RE: HH 15-20 Wellfield Release, Mine Unit 15A, Remediation Proposal, Cameco Resources,
Permit 633

SOIL REMEDIATION PROPOSAL, HH 15-20 WELLFIELD RELEASE

**Mine Unit 15A Wellfield Release, Header House 15-20 Area
Soil Remediation Proposal
Cameco Resources Permit 633**

CAMECO
MINE UNIT 15
HEADER HOUSE 20
SPILL LOCATION 05/03/2011

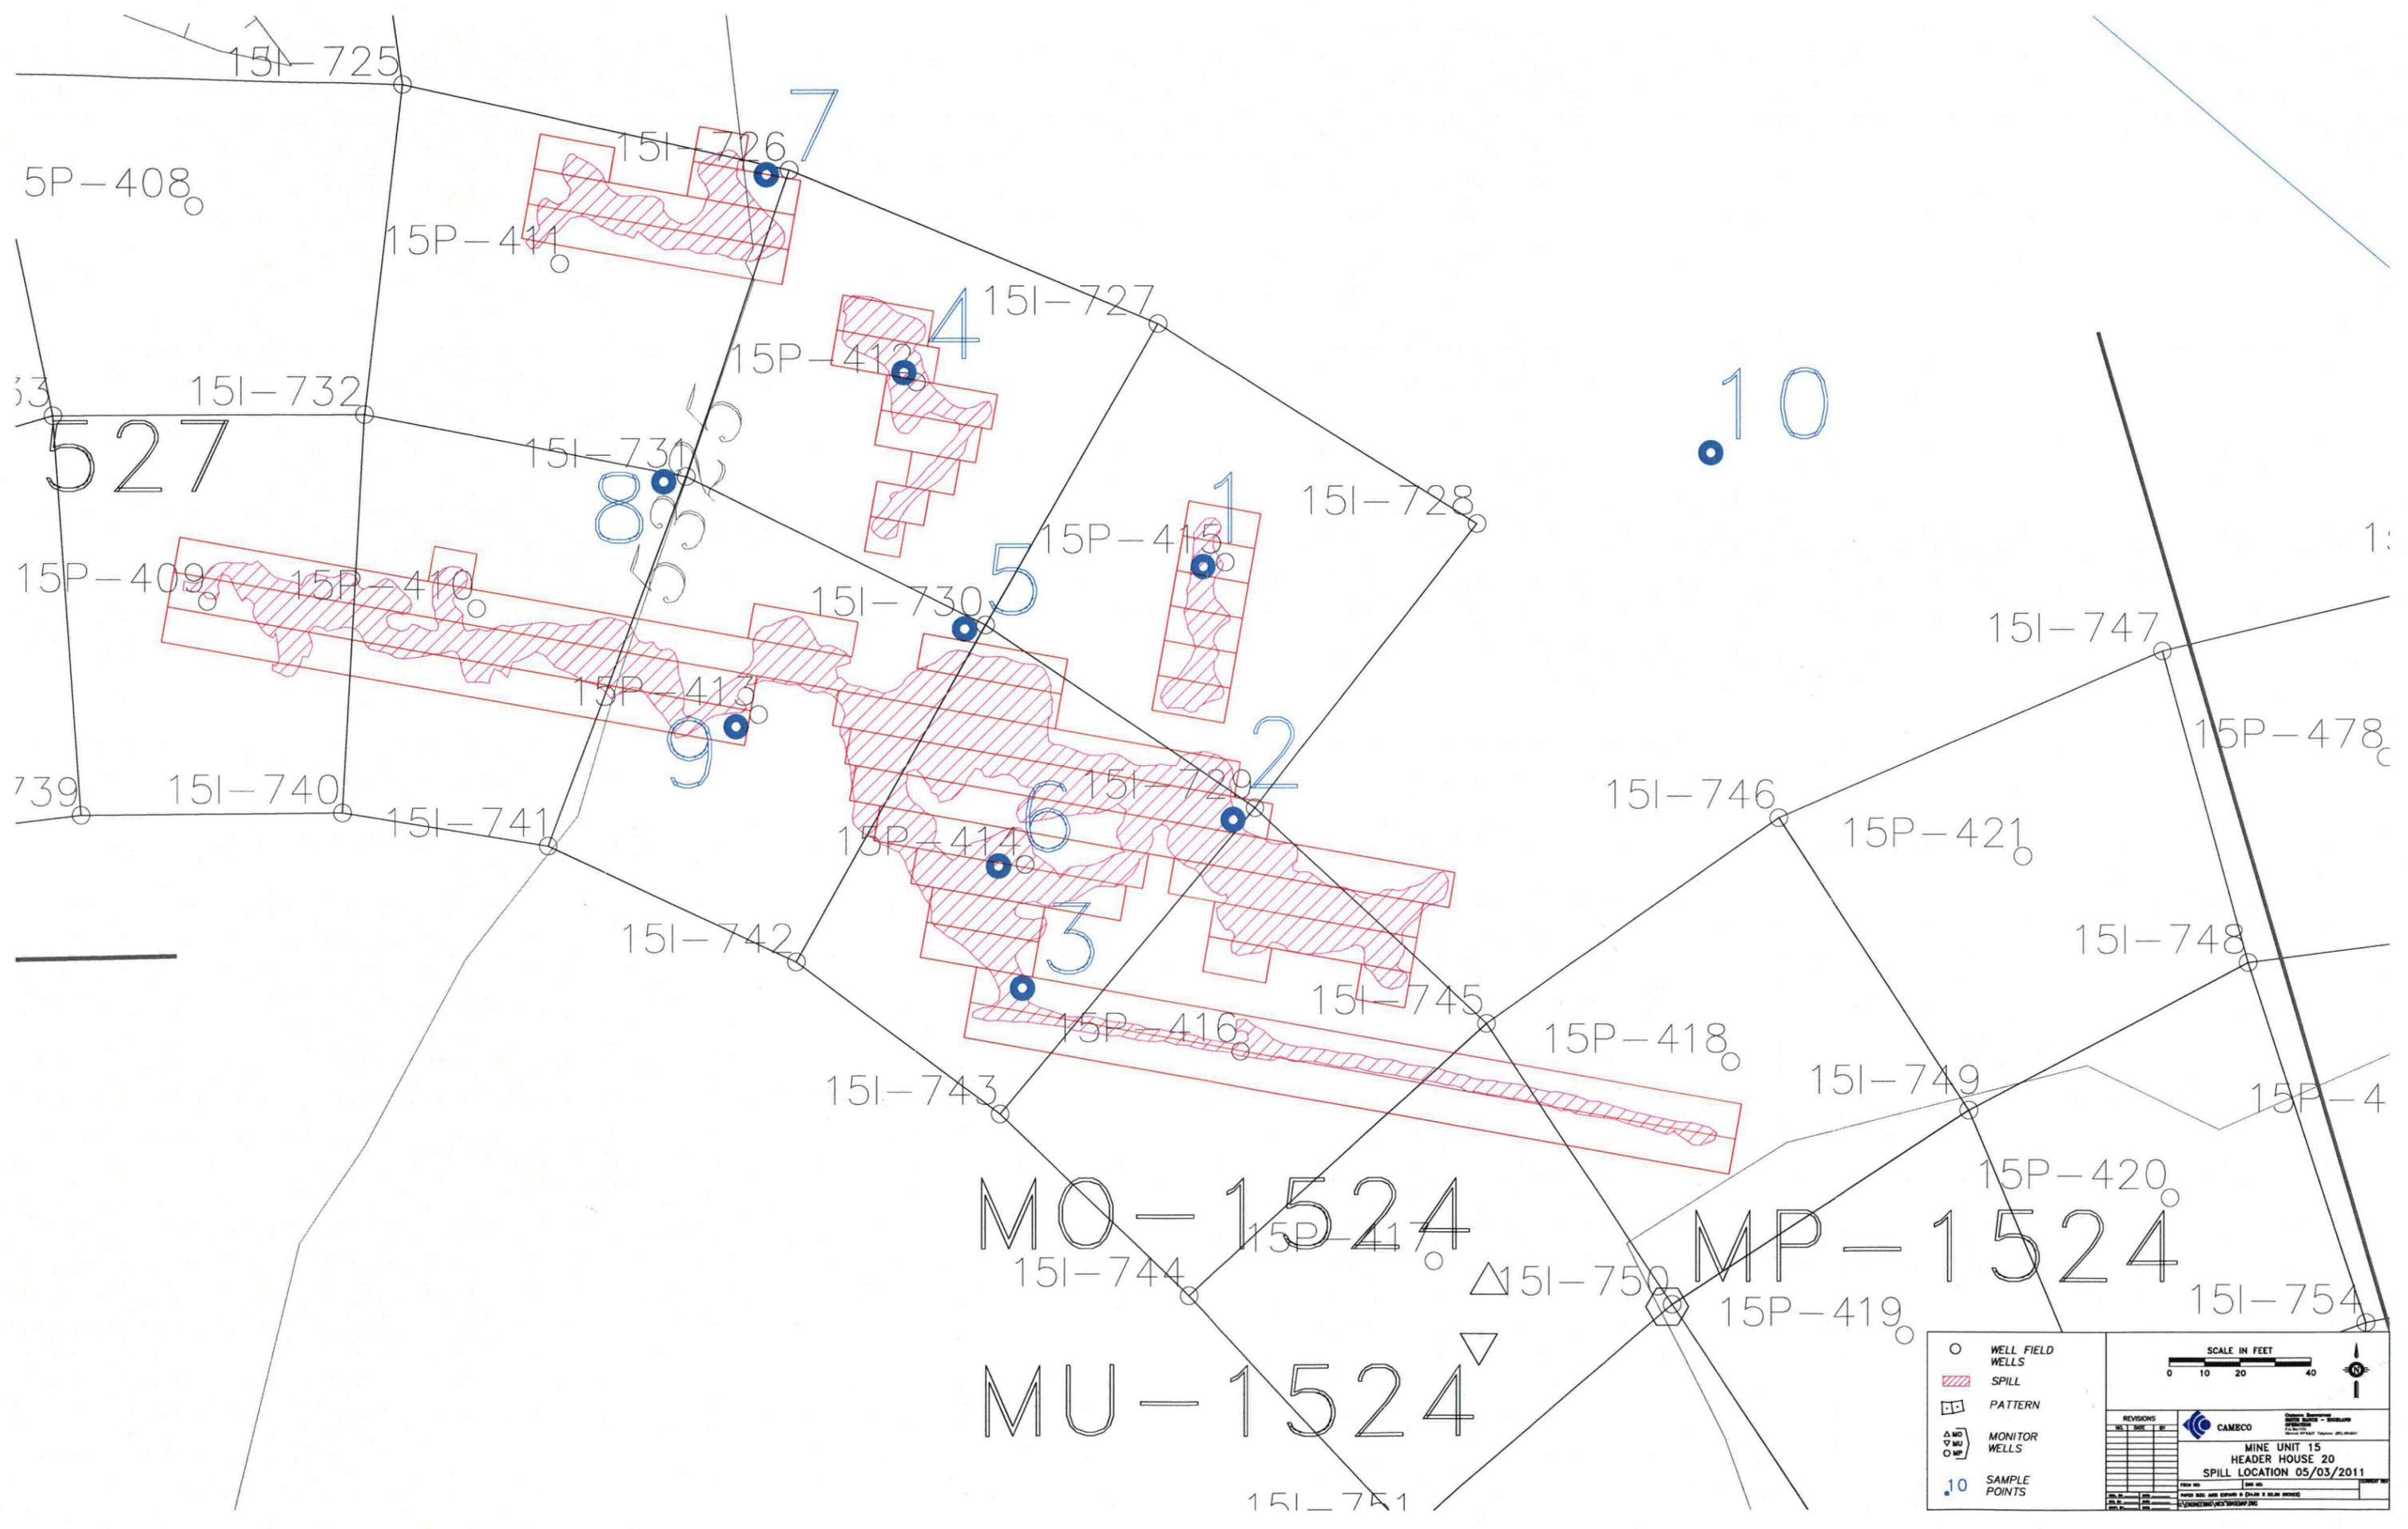
3. *The spill area extends beyond the southernmost line of the grid. An additional line should be added to the south end of the grid. Please add an additional line to the south end of the grid. (SI)*

Cameco Response: A revised map of grid lines is contained in the attached revised proposal.
